UNITED STATES
NUCLEAR REGULATORY COMMISSION

Subject: COOPER NUCLEAR STATION - NRC SPECIAL INSPECTION
REPORT 05000298/2009008

Report: 05000298/2009008

IR 05000298/2009008; 02/23/09 – 05/12/09; Cooper Nuclear Station; Special Inspection into emergency diesel generator lubricating oil pipe cracking and Amphenol connector deficiencies

Figure 1: Lube Oil S-pipe with Flex Joint Showing X-, Y-, and Z-Direction(s)

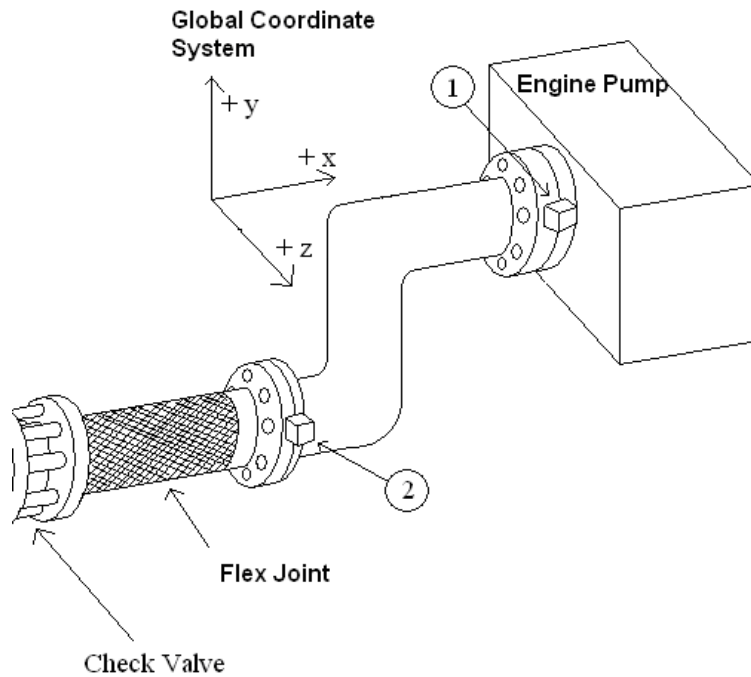
Because of the uncertainty regarding the actual loading, the licensee initiated actions to monitor the vibration in the X-direction and to perform dye penetrant testing of the susceptible weld during each emergency diesel generator monthly operability tests. The licensee planned to continue these compensatory measures until they install a permanent design change. Based on the natural frequency being moved farther from the forcing frequency, the vibration levels being returned to values similar to those prior to the lubricating oil discharge S-pipe replacement in October 2008, no crack initiation identified following several hours of operation, and the continued monitoring until the licensee installed a redesigned lubricating oil discharge S-pipe, the team concluded that Emergency Diesel Generator 1 remained capable of performing its safety function.

The team determined that the measured vibration levels on Emergency Diesel Generator 1 lubricating oil discharge S-pipe increased from 1 to 4 inches per second from August 27, to November 25, 2008, respectively. Maintenance personnel identified this change. However, the maintenance personnel obtained this data in response to a request from the system engineer. Because of the informational nature of the request, the maintenance personnel decided this condition did not warrant documentation in the corrective action program. Further, maintenance personnel decided that continued trending of the vibration levels would be the correct choice of action prior to notifying the system engineer. The team determined that Procedure 0.5, Section 7.1.3 required personnel to initiate condition reports for adverse conditions. Adverse conditions included conditions adverse to quality that reflected any condition that could affect the ability of safety-related components to function within design requirements or affect performance characteristics. The team determined the informality of the request and the failure to use existing processes contributed to this condition.

Figure 2: Comparison of Microstructure Evidence from the Emergency Diesel Generators 1 and 2 Lube Oil Pipe Crack fracture surfaces

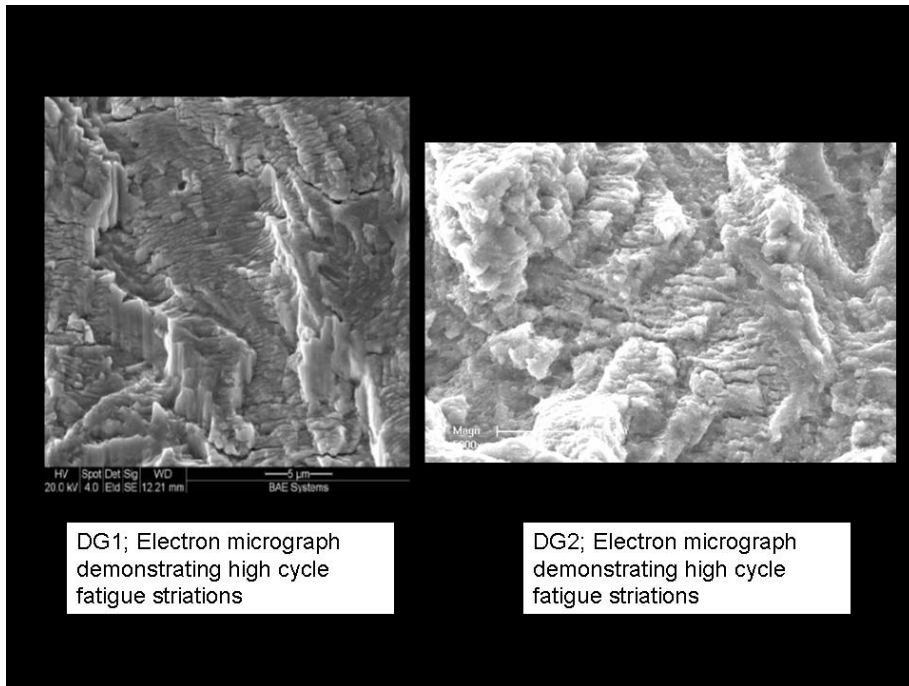
was flat and smooth with clear evidence of beachmarks and striations indicative of a high cycle fatigue failure mechanism (refer to Figure 2). The licensee initiated Condition Report 2009-00098 to resolve the NRC concerns related to misdiagnosis of the failure mechanism for the Emergency Diesel Generator 2 lubricating oil discharge S-pipe crack.

Contrary to the revised root cause analysis, the team determined that the replaced Emergency Diesel Generator 1 lubricating oil discharge S-pipe failed from high cycle fatigue on January 27, 2009, and represented a failure of the licensee to preclude recurrence of a significant condition adverse to quality.

Figure 3 - Closeup of Magnetic Pickup Unit

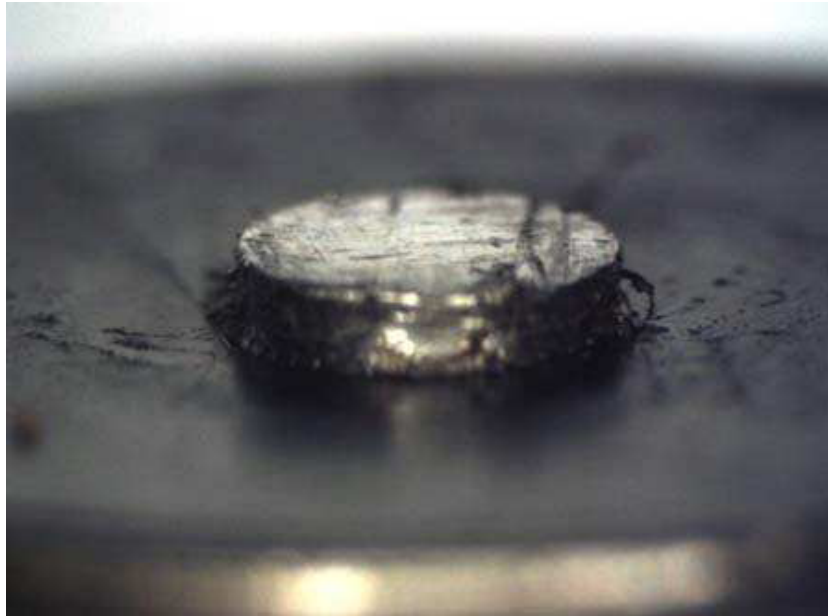
identified very minute metallic debris and rub marks on the probe (refer to Figure 3 in Attachment 6). The licensee determined the speed sensing gear impacts on the magnetic pickup unit probe produced the load swings observed during the April 20 and 21, 2008, tests. Since the licensee replaced the digital reference unit and magnetic pickup unit, verified the gap settings on the new magnetic pickup unit probe, and successfully completed operability and post maintenance tests without anomalies, the licensee concluded Emergency Diesel Generator 2 would perform its required safety function (refer to Figure 4 in Attachment 6).

Figure 4: Typical Magnetic Pickup Arrangement

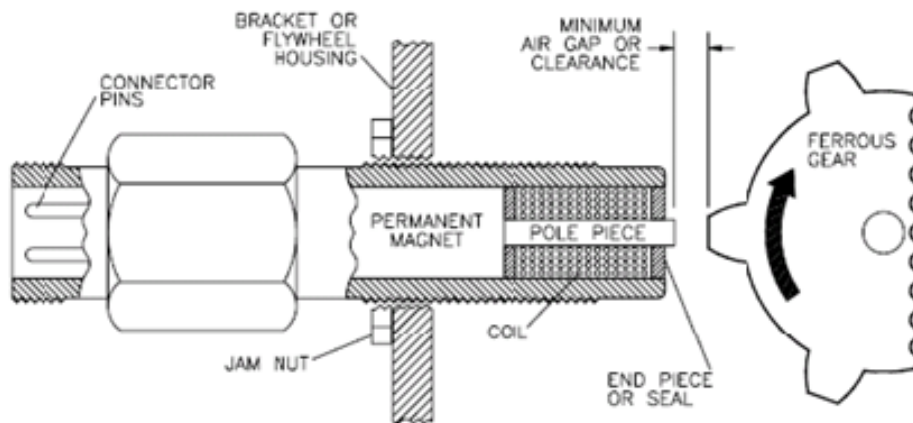
The second instance related to the event on April 21, 2008, that resulted from an improperly gapped governor magnetic pickup unit (a different Amphenol connector). In response to this event, the licensee replaced the magnetic pickup unit and had a laboratory analyze the damaged magnetic pickup unit. In this example, the team concluded that Procedure 7.3.28.5 did not include precautions related to disturbing the magnetic pickup unit gap settings or for resetting the gap after replacing a magnetic pickup unit.
